Access Compliance Report

Public Rights-of-Way

Intersection ID: 8132	Main Street: OLD_CONCORD_RD	Cross Street: BRANCH_HILL_CR	Location:	N
ADA ID: A75B17897F1B	Ramp Type: Perp	Initial Pass/Fail: Fail	Overall Compliance: No	Severity Score: 25
Codes/Mitigation Info/Possible Solution		Field Measurements/Component Compliance

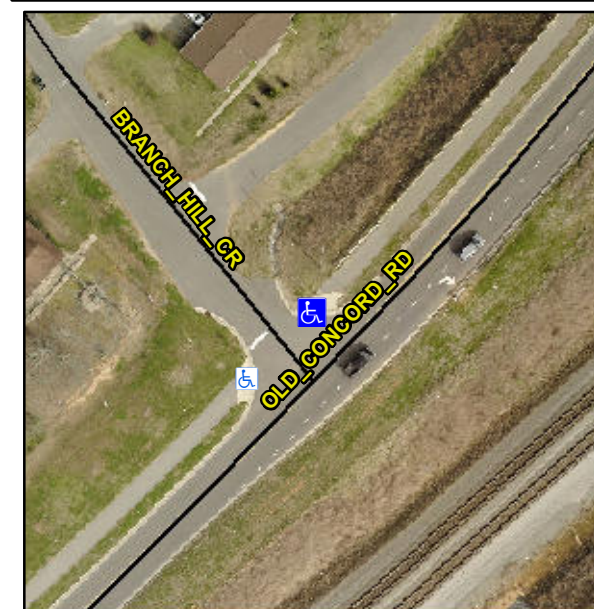
Not Found, R304.2.2, R304.5.3

Compliance	Description	Data	Compliance	Description	Data
N/A	Ramp Length (in)	79.0	No	Ramp Slope (%)	8.8
Yes	Ramp Width (in)	77.0	No	Ramp XSlope (%)	6.3
N/A	Flare Type LT	N/A	N/A	Flare Type RT	N/A
N/A	Flare Slope LT (%)	N/A	N/A	Flare Slope RT (%)	N/A
N/A	Flare Traversable LT?	N/A	N/A	Flare Traversable RT?	N/A
N/A	Landing Length (in)	N/A	N/A	DWS Provided?	N/A
N/A	Landing Width (in)	N/A	N/A	DWS Contrast?	N/A
N/A	Landing Slope (%)	N/A	N/A	DWS Length (in)	N/A
N/A	Landing X Slope (%)	N/A	N/A	DWS Full Width?	N/A
N/A	Landing Curb? (Y/N)	N/A	N/A	DWS Offset (in)	N/A
N/A	Shared Landing?	N/A			
N/A	Gutter Ponding?	N/A	N/A	Gutter Slope (%)	N/A
N/A	Gutter Lip Ht (in)	N/A	N/A	Gutter X Slope (%)	N/A
N/A	Painted X Walk1?	No	N/A	Painted X Walk2?	N/A
	X Walk 1 Direction	To W		X Walk 2 Direction	N/A
N/A	X Walk 1 Width (in)	N/A	N/A	X Walk 2 Width (in)	N/A
	X Walk 1 Slope (%)	4.0		X Walk 2 Slope (%)	N/A
	X Walk 1 X Slope (%)	3.2		X Walk 2 X Slope (%)	N/A

Remove & Replace Entire Ramp.
